## **Submission from the WA Expert Consumer Panel on the Draft Benchmark Reserve Capacity Prices Determination.**

The Economic Regulation Authority of WA (ERA) has issued a draft 2026 determination of the BRCPs for the 2028/29 WEM capacity year of \$491,700 per Megawatt (MW) per year for both the Peak and Flexible BRCPs.<sup>1</sup> This is 36 per cent higher than the 2025 BRCPs of \$360,700 per MW per year which were also significantly higher than BRCPs have been since market start (see the following chart which shows the increases since 2021/22).

**Figure 1: BRCPs from the 2021/22 capacity year to 2028/29**

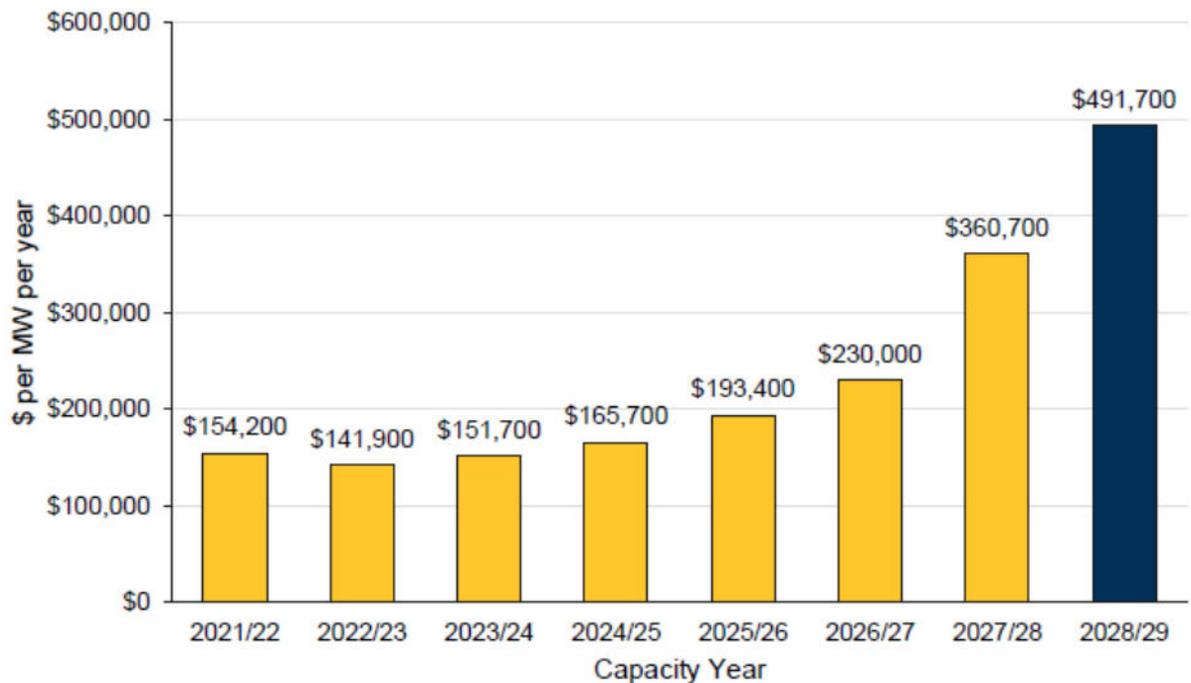
This extraordinary escalation in the BRCPs raises serious concerns for energy consumers because higher wholesale electricity prices mean higher retail electricity costs, particularly for businesses who are exposed to unregulated prices.
